Project	IEEE 802.16 Broadband Wireless Access Working Group < http://ieee802.org/16 >	
Title	Restructuring of Clause 7 of 802.16e	
Date Submitted	2005-10-06	
Source(s)	David Johnston Intel Corporation Hillsboro, OR USA	Voice: 502 264 3855 Fax: mailto:dj.johnston@ieee.org
Re:	Comments 8007 and 8008 in sponsor recirculation of 802.16	
Abstract	A proposal, with specific text to restructure clause 7, making the editorial directions clear, accomodating both PKMv1 and PKMv2 and making the section numbers correct with respect to IEEE 802.16-2004 and corrigendum 1 so that it is possible to correctly amend the base document with the text into 802.16e.	
Purpose	Consider and adopt this text into the 802.16e draft as a resolution of comments 8007 and 8008.	
Notice	This document has been prepared to assist IEEE 802.16. It is offered as a basis for discussion and is not binding on the contributing individual(s) or organization(s). The material in this document is subject to change in form and content after further study. The contributor(s) reserve(s) the right to add, amend or withdraw material contained herein.

Restructuring of Clause 7 of 802.16e

The following text represents a complete repl

Figure 130j—Security sublayer

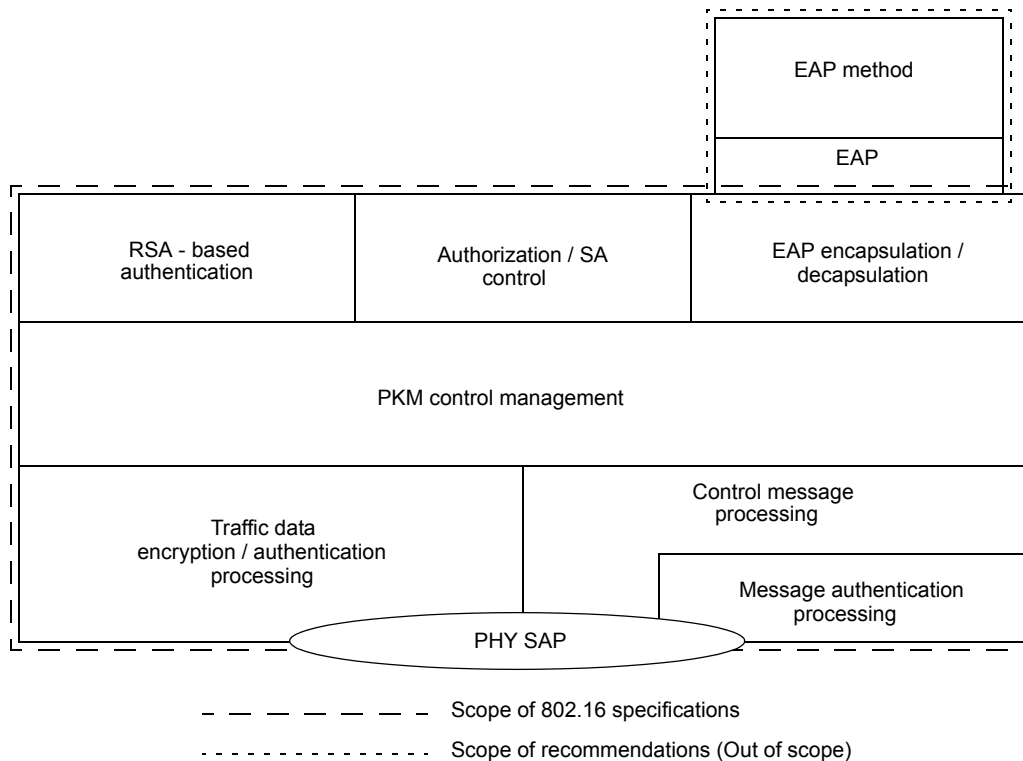
The protocol stack for the security components of the system are shown in Figure 130j.

[Insert new figure:]
